Product Change Notification

PCN NUMBER	PCN044
DATE	27 March 2023
AFFECTED P/N	AM-RX12E-433P

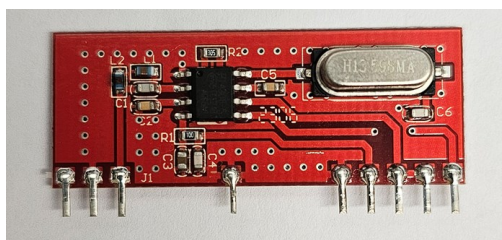
Change of leg length.
Was 6mm long is now 2.75mm as drawing below

NOTES
Pins on 0.1" pitch
Pin Dims : 0.7 x 0.2mm

New part will be AM-RX12E**S**-433P
